UNC Charlotte Phase 16

Addendum #4

Revision Narrative

2021-09-08

E-008

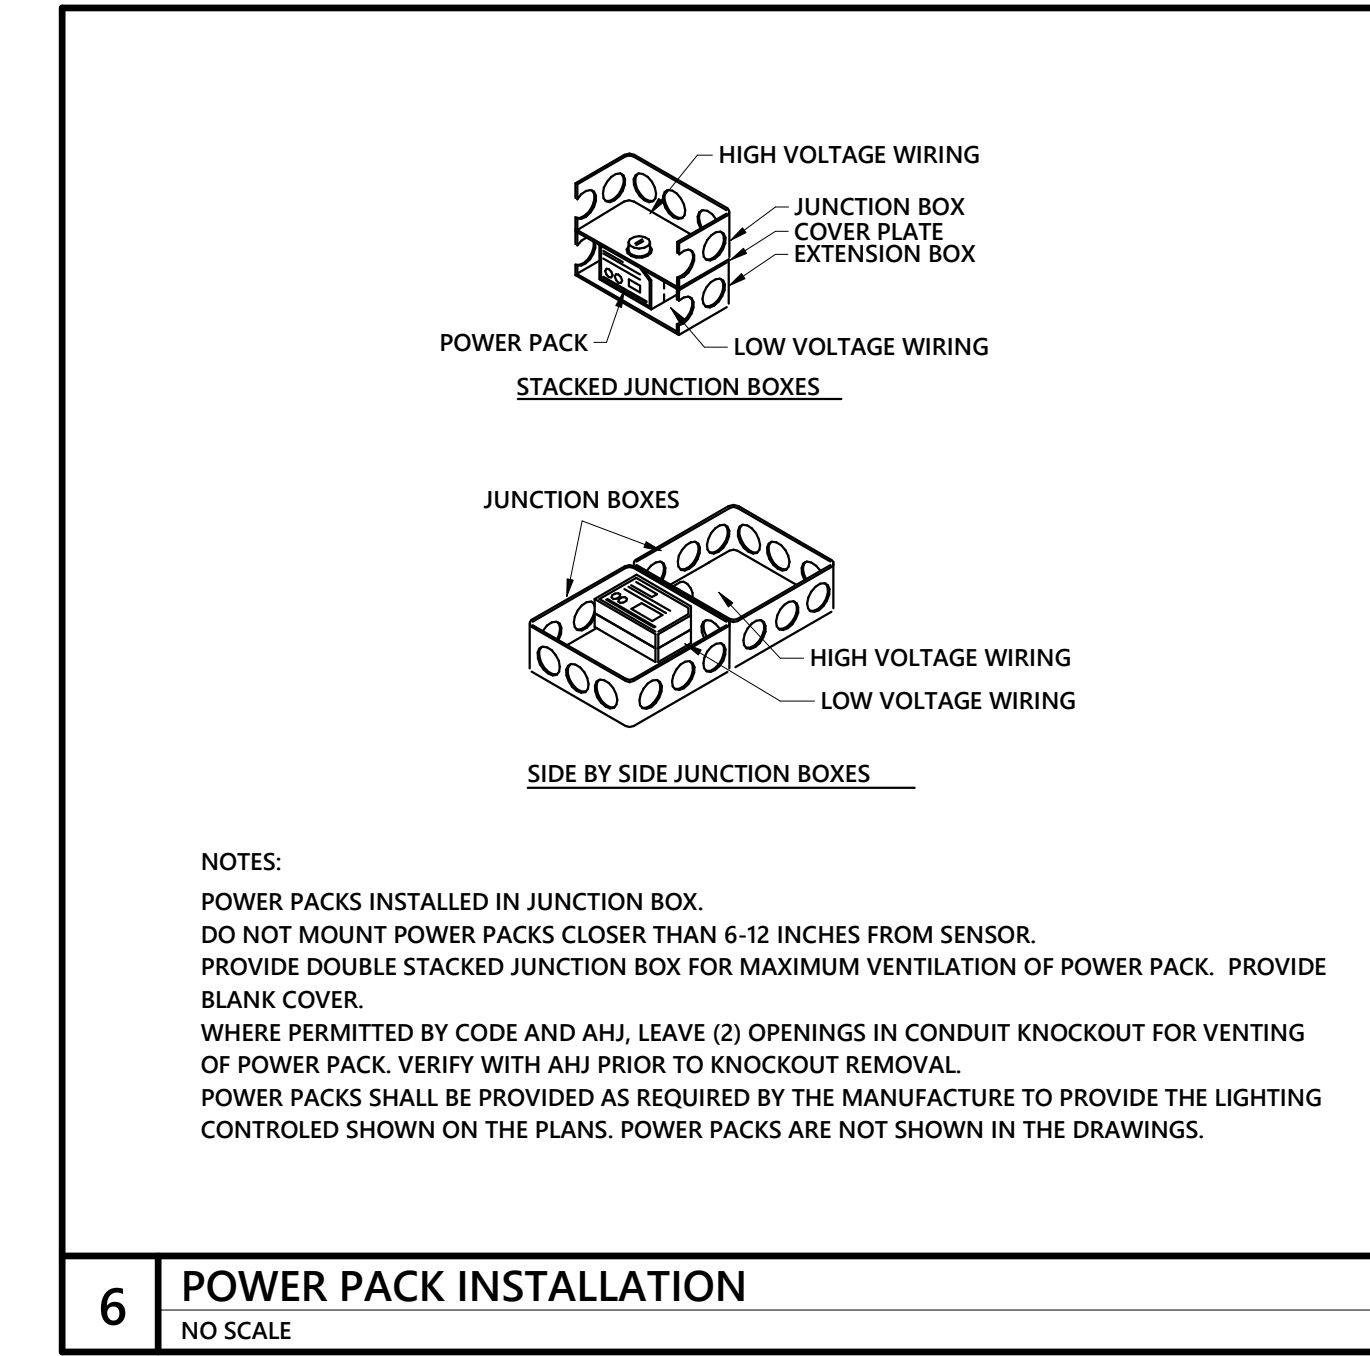
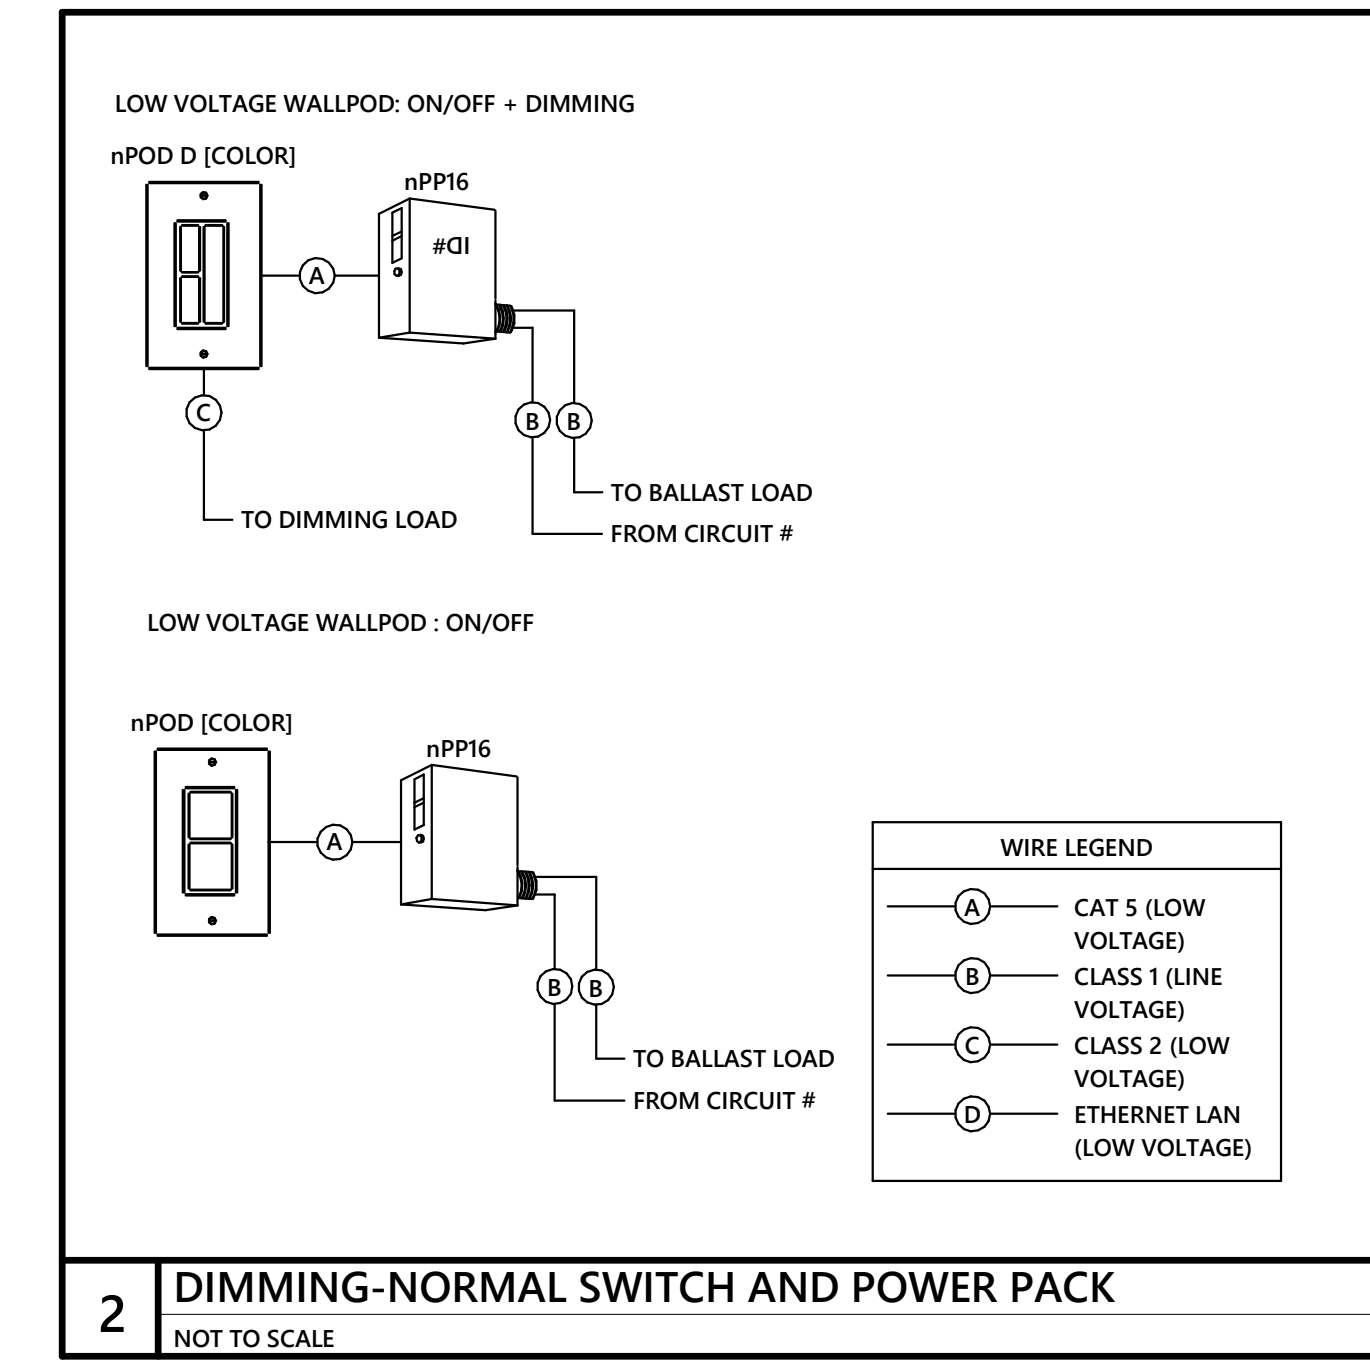
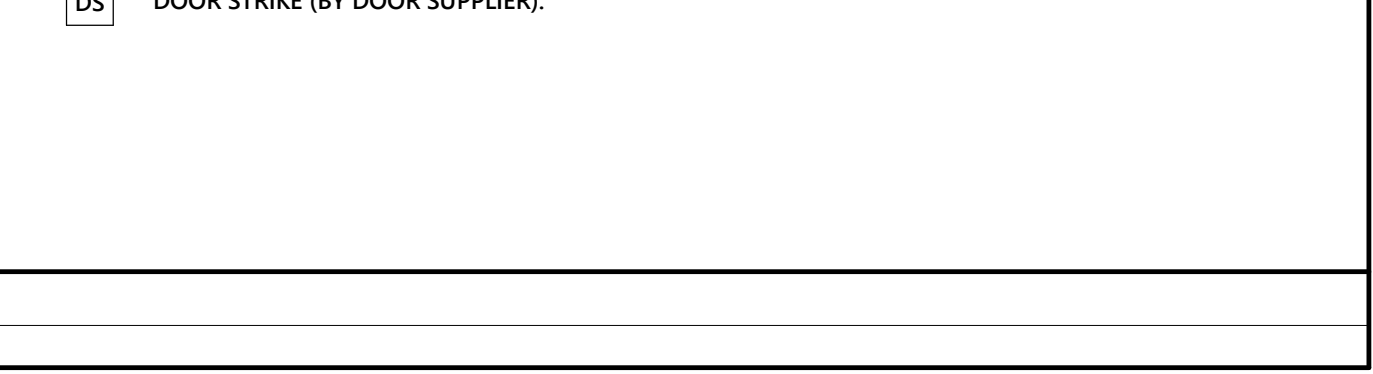
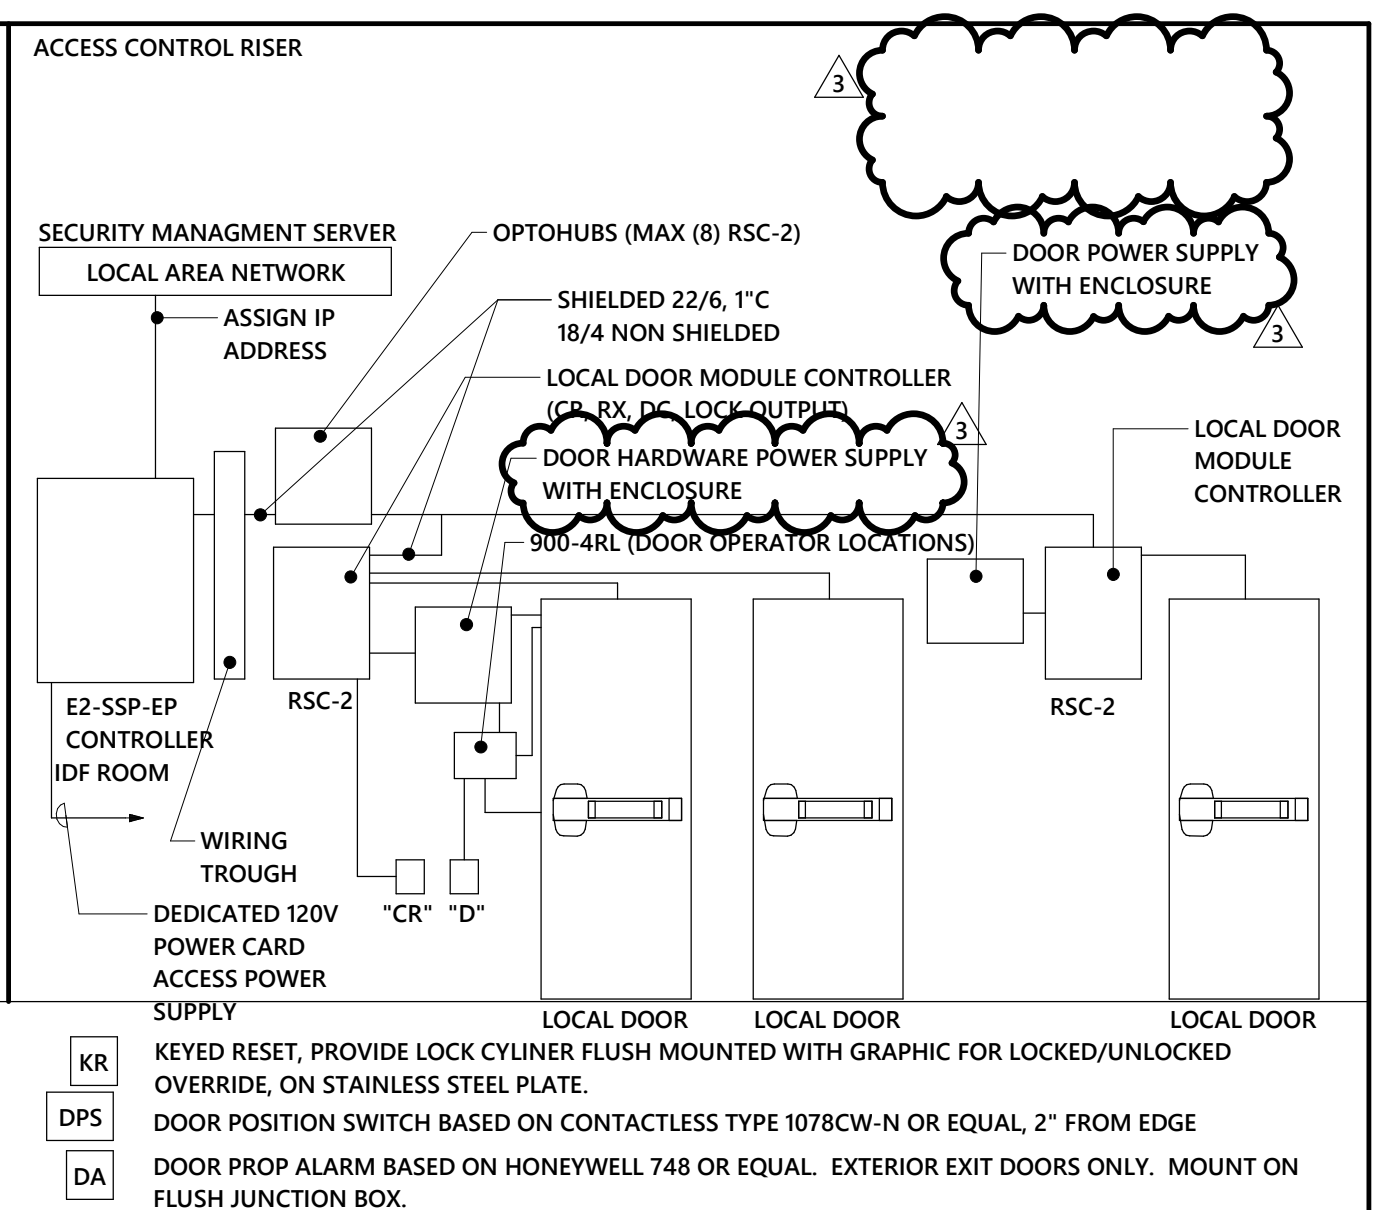
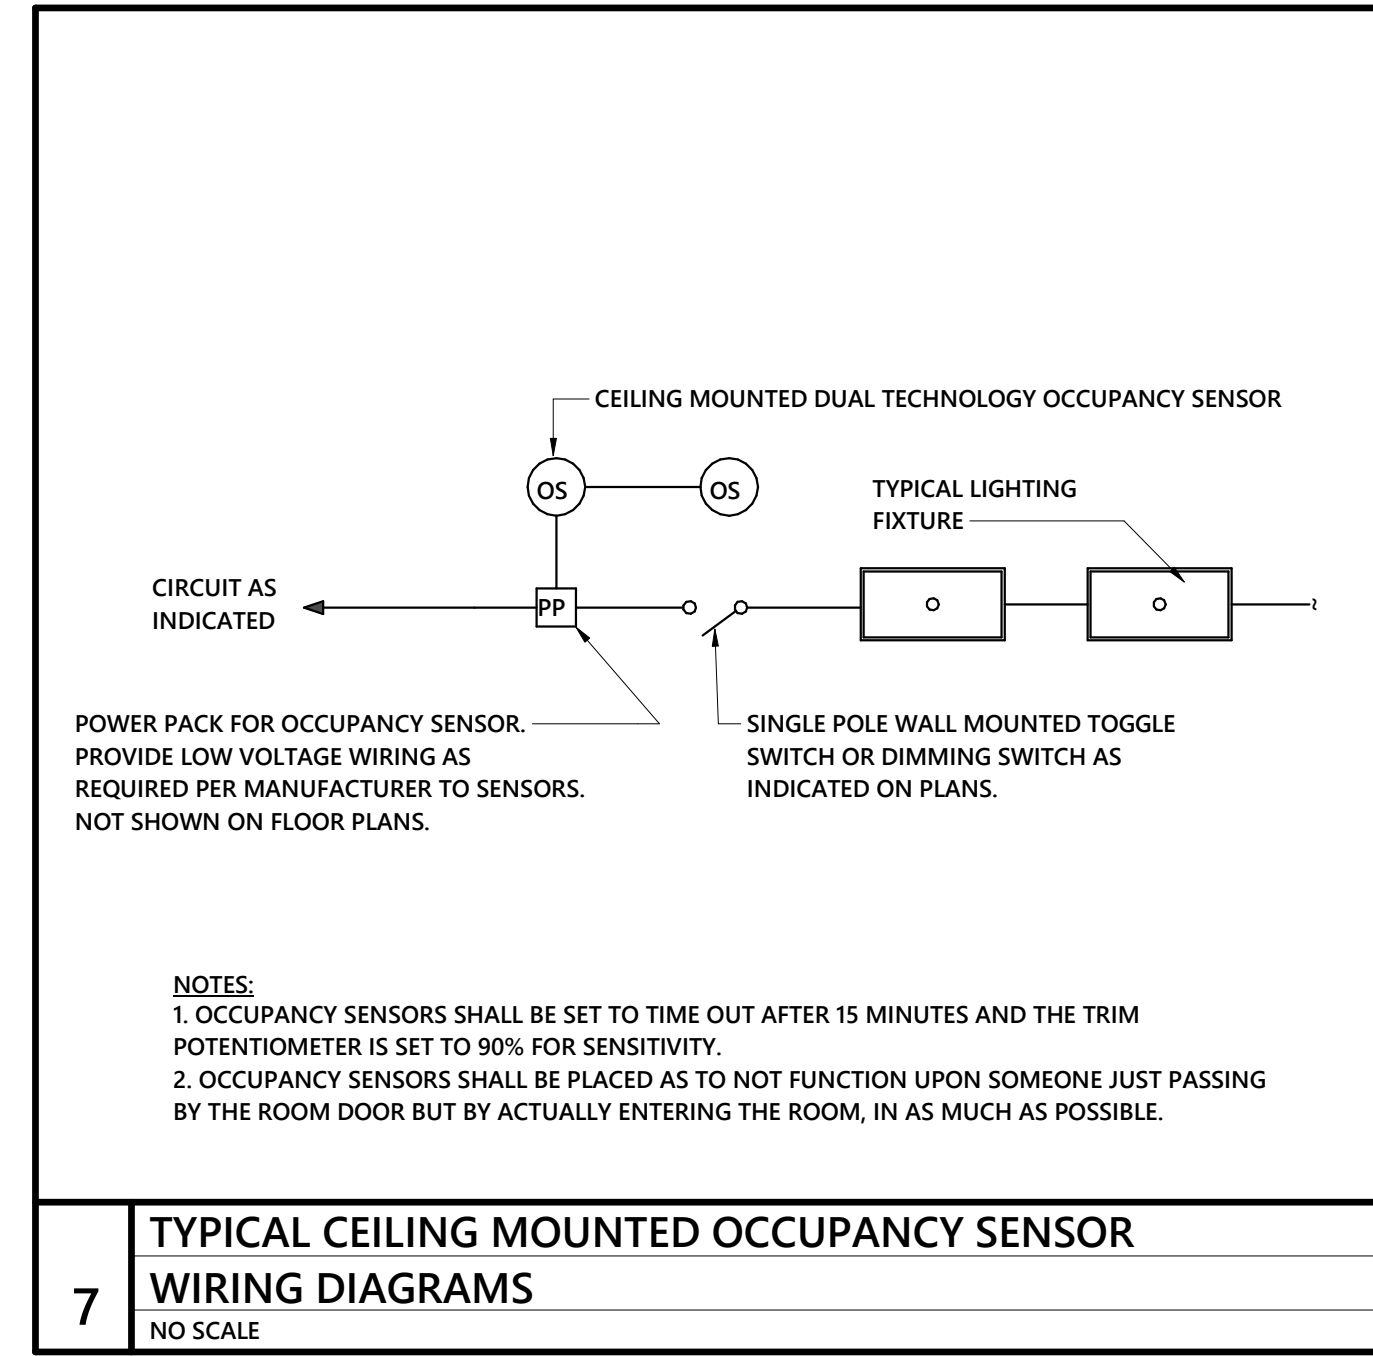
E-008 – Revisions for clarifications on access control details.
